Technical Manual for 48K Words Upgrade Feature for RC 3601 D Central Unit.

RCSL No: 44-RT 1386

This paper contains drawings and description of the modifications which change the central processor RC3601D to RC3602D with 48K word memory.

Fig. 1.1 Circuit diagram for driver for $\overline{MAB0}$

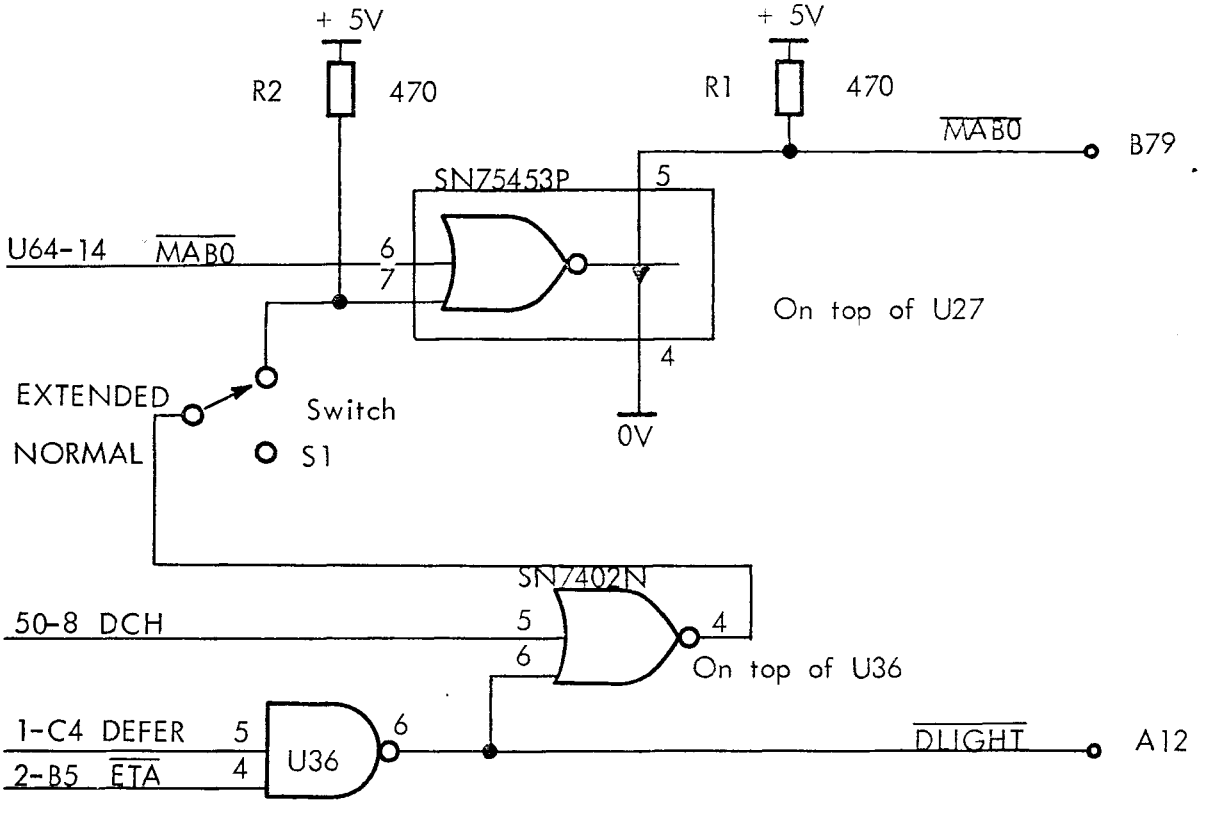
The modification supplies the central processor with a driver for the $\overline{MAB0}$ signal, and a switch which eliminates the memory extension.

Fig. 2.: Circuit diagram with modification making the DR124F memory respond to MA80. The Diagram is to be used as Schematic Diagram Sheet 2 of 7 in the technical manual for DR124F.

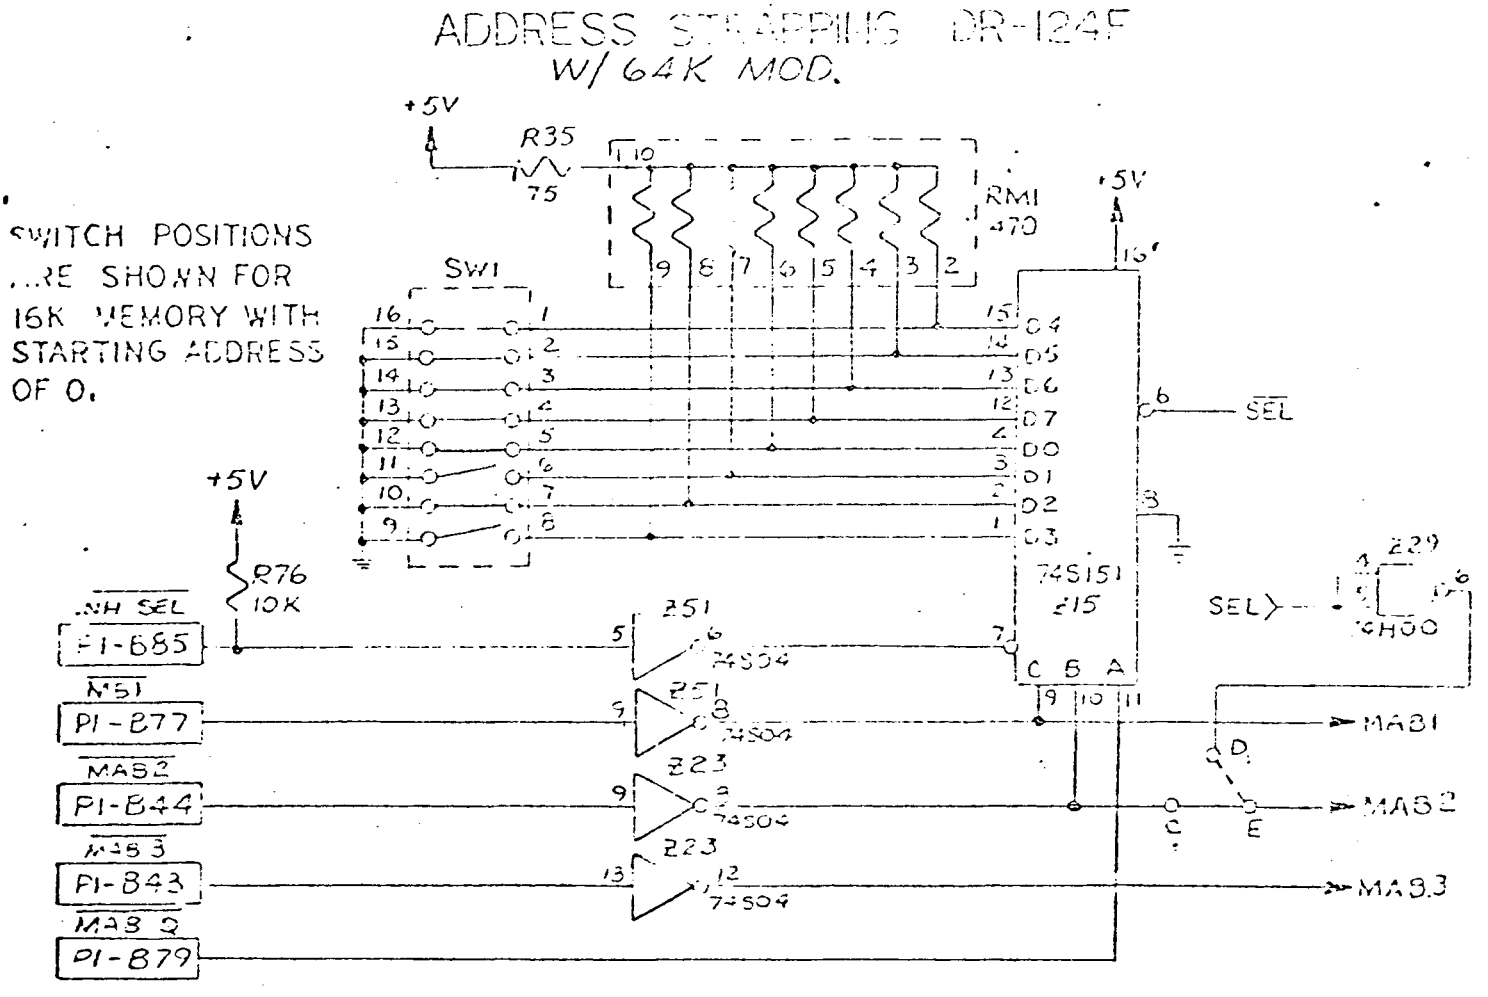
This modification makes the Memory DR124F respond to $\overline{MA80}$.

Unit	DCC 701
Dwg. No.

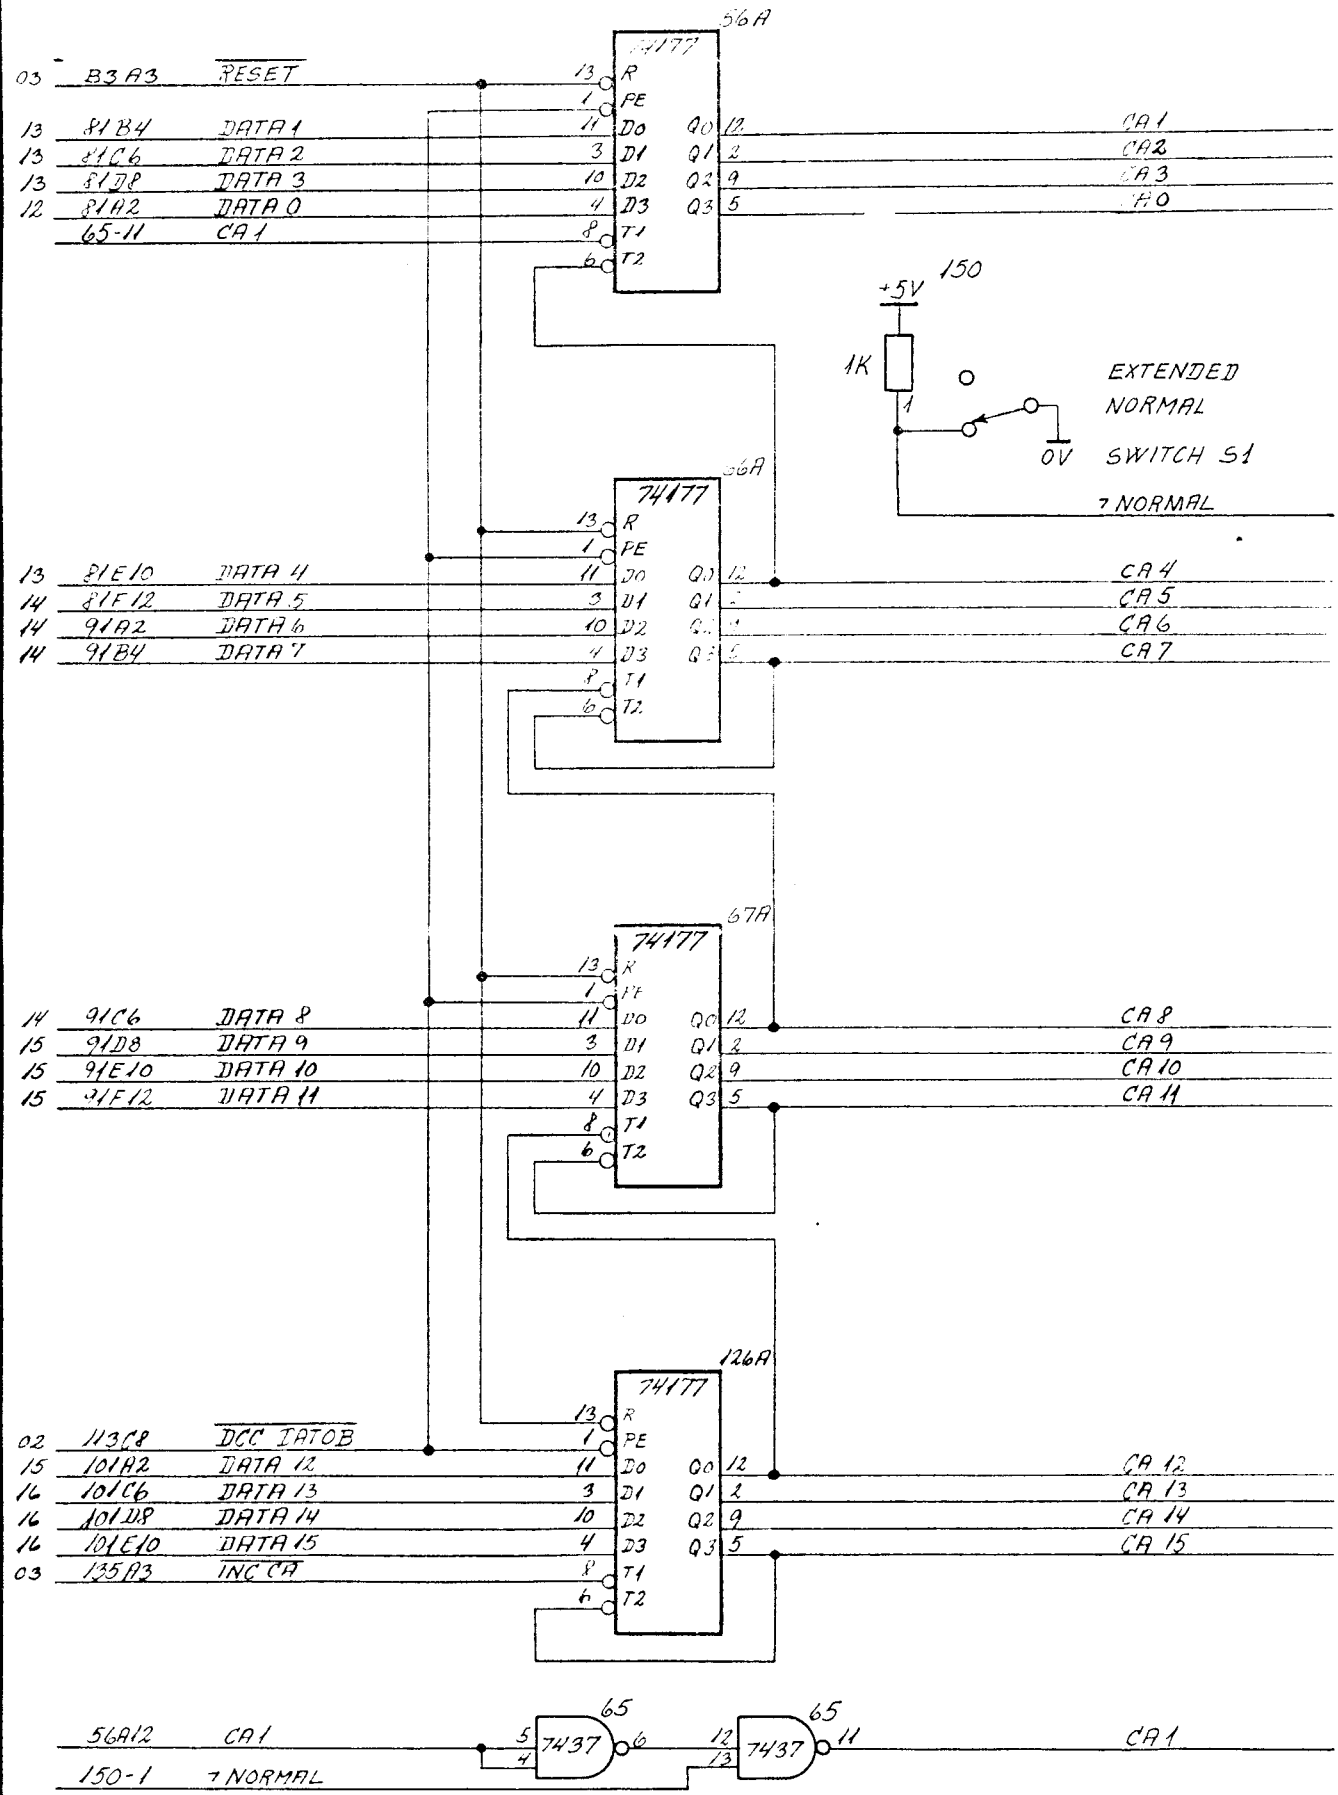
This modification changes the core address register from a 15-bit register/counter to a 16-bit register/counter.

The switch is used to force the CA0 output to logical zero when using the Testprogram.

Page 6 shows the new Logic Diagram for DCC701 page 09.
